## **Merged Document Report**

### **Application No.: PL9204**

# UTILITY PLAN FOR OF FLOUR BLUFF ESTATES BLOCK D, LOTS 13R & 14R

**PLAT OF  
FLOUR BLUFF ESTATES  
BLOCK D, LOTS 13R & 14R**

# PLAT OF FLOUR BLUFF ESTATES BLOCK D, LOTS 13R & 14R

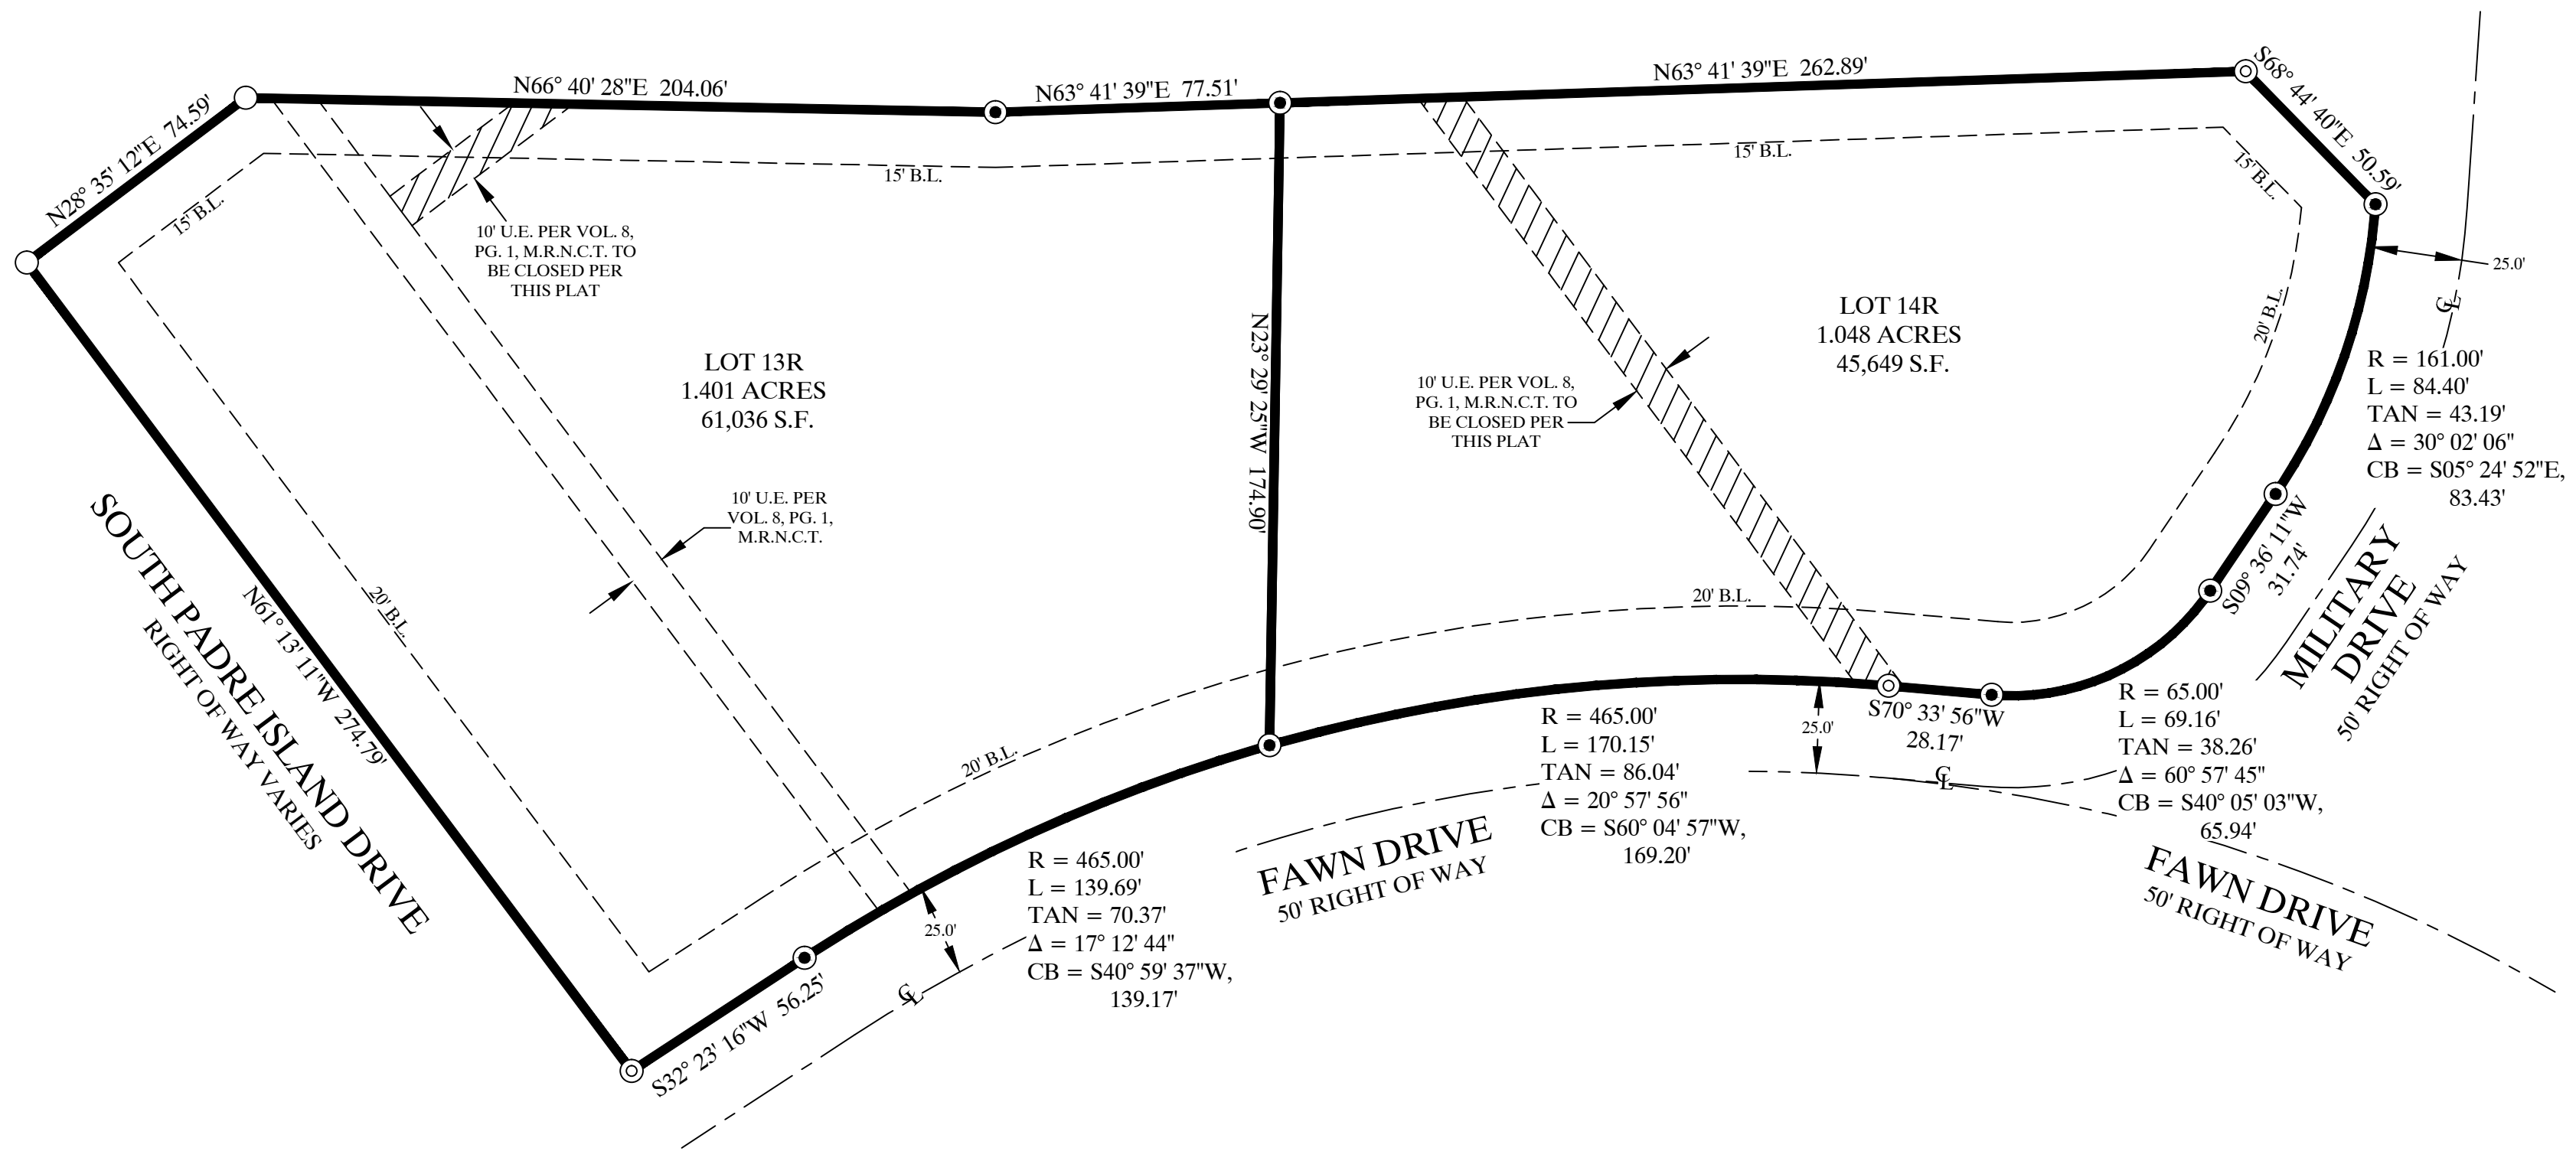
<b>Comment ID</b>	<b>Page Reference</b>	<b>Annotation Type</b>	<b>Author : Department</b>	<b>Status</b>	<b>Review Comments</b>	<b>Applicant Response Comments</b>
4	P002	Note	Bria Whitmire : DS	Closed	Improvements Required for Recordation, per UDC 8.1.4. A. Streets: no Sidewalks: yes, at site development B. Water: no (EACH lot must have individual access and provide connectivity to neighboring lot) Fire hydrants: not for platting, possibly for site development (nearest hydrant must be 300 feet for

Comment ID	Page Reference	Annotation Type	Author : Department	Status	Review Comments	Applicant Response Comments
					<p>commercial, 600 for residential)  C. Wastewater: no (EACH lot must have individual access and provide connectivity to neighboring lot)  D. Stormwater: no, however site development shall be mitigated to not increase runoff  E. Public open space: no (UDC 8.3)  F. Permanent monument markers: no  Please note, improvements required should be constructed to city standards, found in Article 8 and the IDM.</p>	
1	P001	Note	Mark Zans : LD	Closed	<p>TxDot comments: Informational only_  TxDOT permits will be issued in accordance with access management standards and all applicable state and federal laws, including relevant rules and regulations. Considerations will include access connection spacing, materials, geometrics, accessibility, and other design specifications, as well as the impact on drainage and hydraulics, utility location or relocation, and environmental effects resulting from the requested construction of an access connection (43 Tex. Admin. Code § 11.52, 2020).</p> <ul style="list-style-type: none"> <li>• Drainage improvements must accommodate runoff from the upstream drainage area in its anticipated maximum "build-out" or "fully developed" condition and should be designed to prevent overloading the capacity of the downstream drainage system.</li> <li>• If the owner responsible for maintaining the permanent stormwater or water quality control fails to maintain it to TxDOT ROW standards, the owner must rectify the issue.</li> <li>• Any development that anticipates an increase in existing traffic generation may be required to conduct a traffic study. The necessary improvements identified in the traffic study may need to be constructed by the developer, based on TxDOT's discretion and approval, prior to the access connection being establish.</li> </ul>
